Report No:	REP11-09-01
File No:	RM110076
Report Date:	24 August 2011
<b>Decision Required</b>

**Report to:** Environment & Planning Subcommittee

**Subject:** **NORTON FAMILY TRUST**

- 1.1 This report is my assessment of an application to subdivide a 5.7 hectare property, located at Pigeon Valley Road, Wakefield, to create three rural residential allotments.
- 1.2 The application that is subject of this report has been amended from the application that was originally lodged and notified. The amendments relate to a change in the position of the access servicing two of the allotments.

# Appendix 'A'

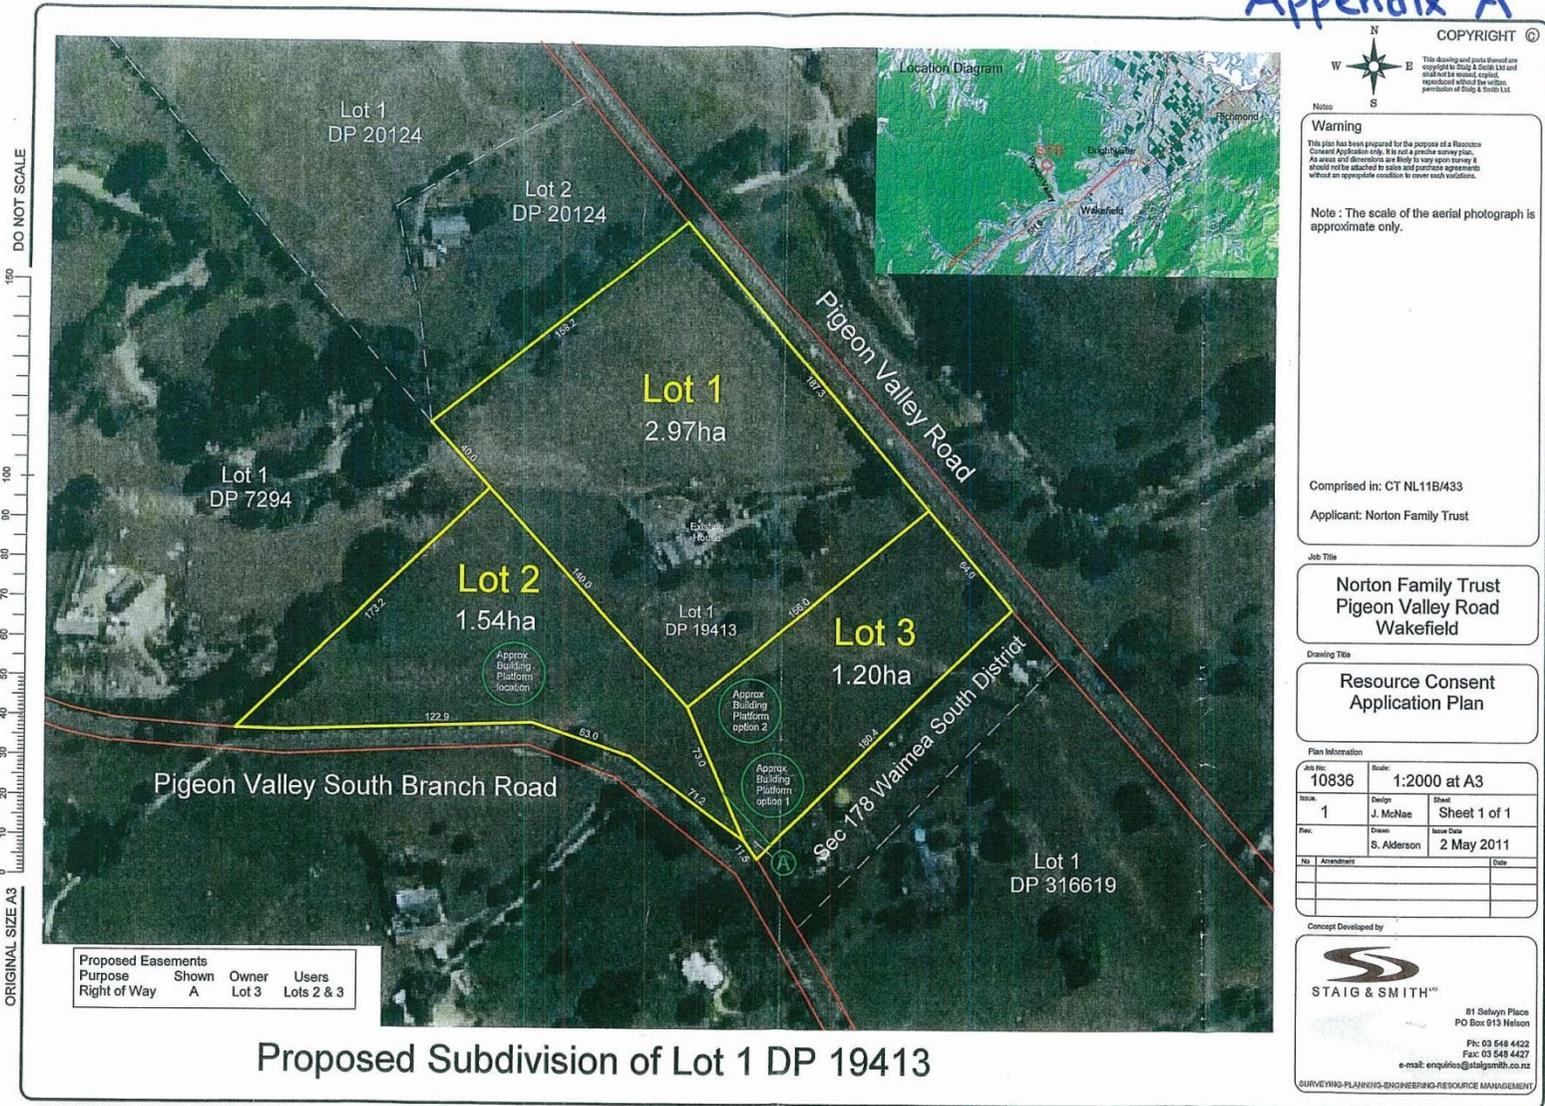
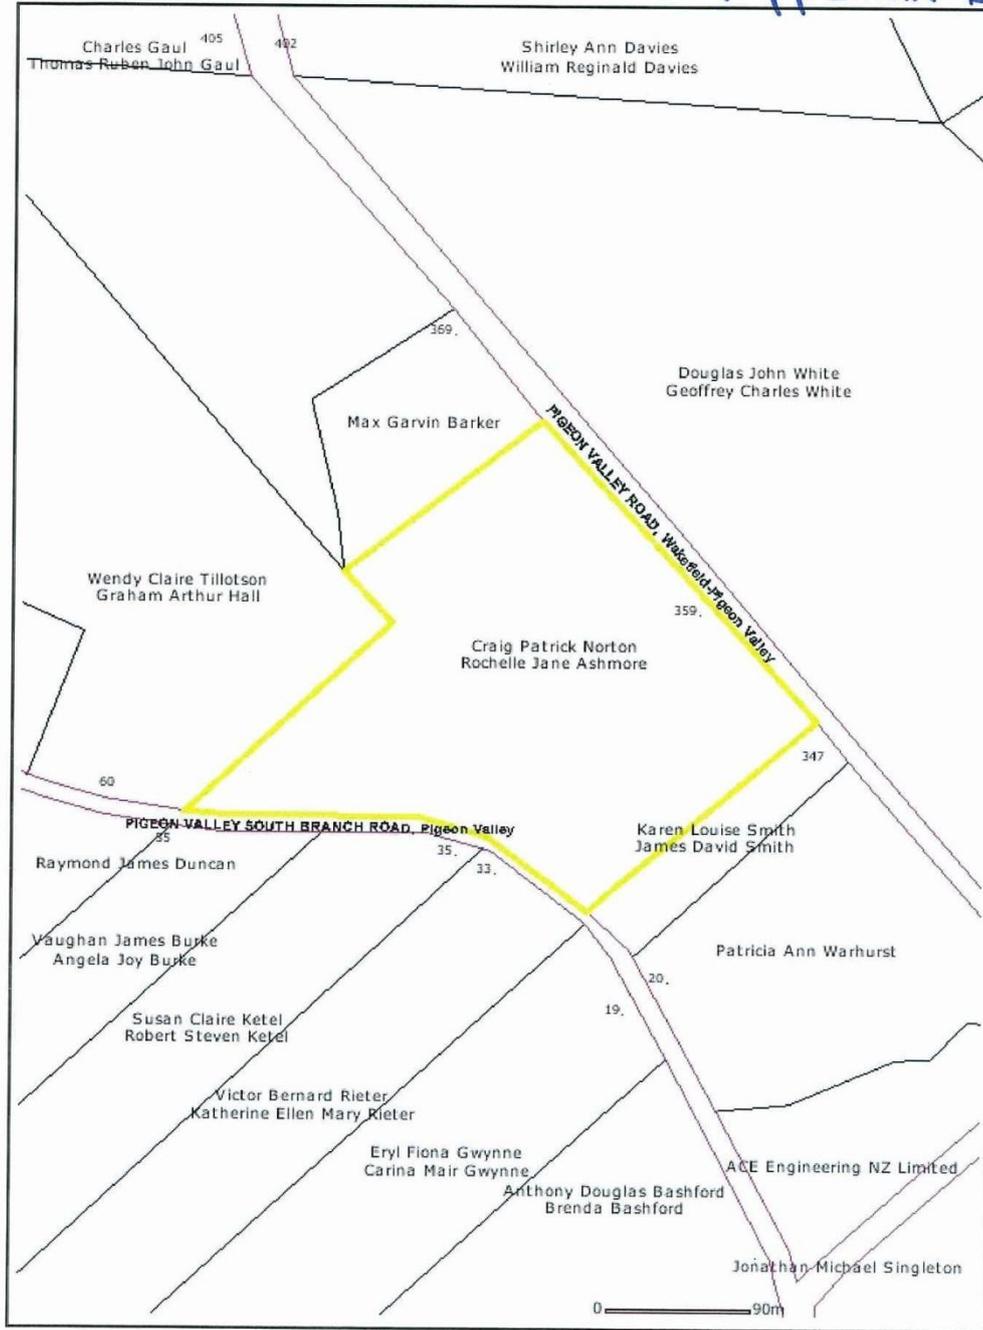
- 3.1 The proposal is to subdivide the land to create three allotments as shown on the plan attached as Appendix A, being:
- (a) Lot 1 of 2.97 hectares containing the existing dwelling;
  - (b) Lot 2 of 1.5 hectares being a vacant rural residential site;
  - (c) Lot 3 of 1.2 hectares being a vacant rural residential site.
- 3.2 The proposal also includes an application to construct a right-of-way to provide access to Lots 2 and 3.

- (e) As stated, the current application has been amended from the original application. This is because as a result of submissions the applicant engaged a traffic engineer who recommended an amended crossing place to service Lots 2 and 3. The traffic engineer's report is attached as Appendix D. The conclusion of that report is that the amended access point provides sufficient sight visibility for safe exit and entrance to the site via a right-of-way to service Lots 2 and 3.

- (a) That the right-of-way shown "A" on the application plan be duly granted or reserved by reference in Council's Section 223 recital.
- (b) That the right-of-way and vehicle crossing servicing Lots 2 and 3 be constructed generally in accordance with the diagram attached as Appendix G.
- (c) That prior to undertaking any construction works engineering plans, prepared in accordance with Council's Engineering Standards 2008, be submitted to Council for approval. The engineering plans are to include detail of areas to be sealed, drainage and vegetation clearance.
- (d) That all works be undertaken in accordance with the approved plans.

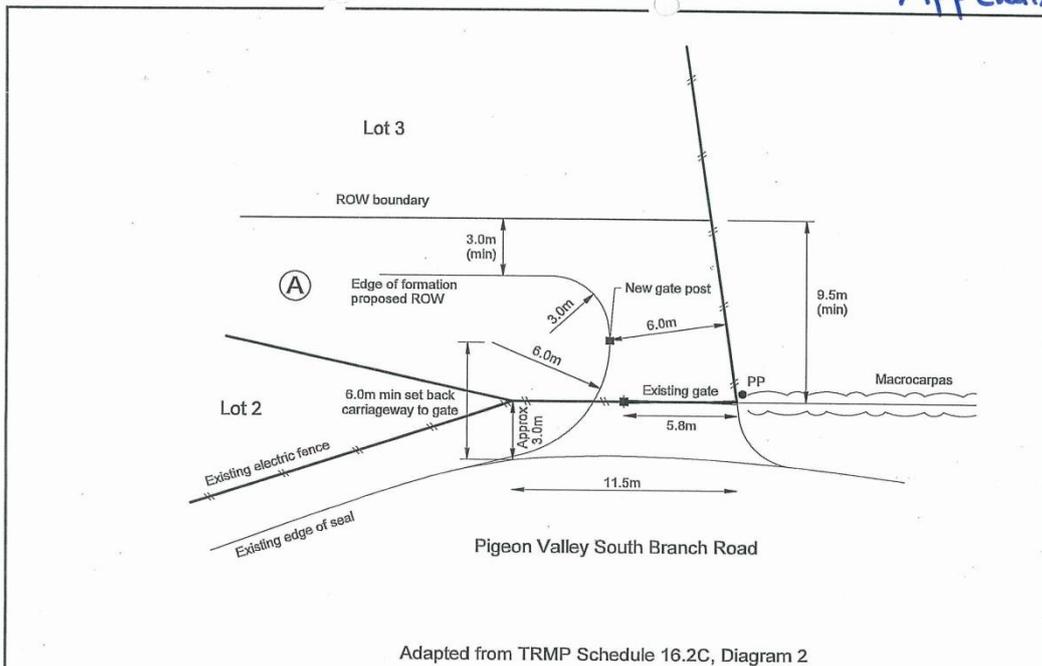
The soil will be the limiting factor for the disposal of wastewater. The site and soil assessment was undertaken by Tasman Consulting Engineers (TCE). TCE are on the TDC accredited list of for site and soil assessment. The soil has been categorised as Category 6 (poorly draining clay). I regard this site and soil assessment as a realistic assessment in this case.

TCE proposes to use secondary treated effluent applied to land via dripper lines. At this point in time this is the standard solution for Category 6 soils. The effluent is applied over a large area at a low rate minimising the potential offsite effects.

I do not see the need to place any specific conditions about the wastewater on the subdivision.
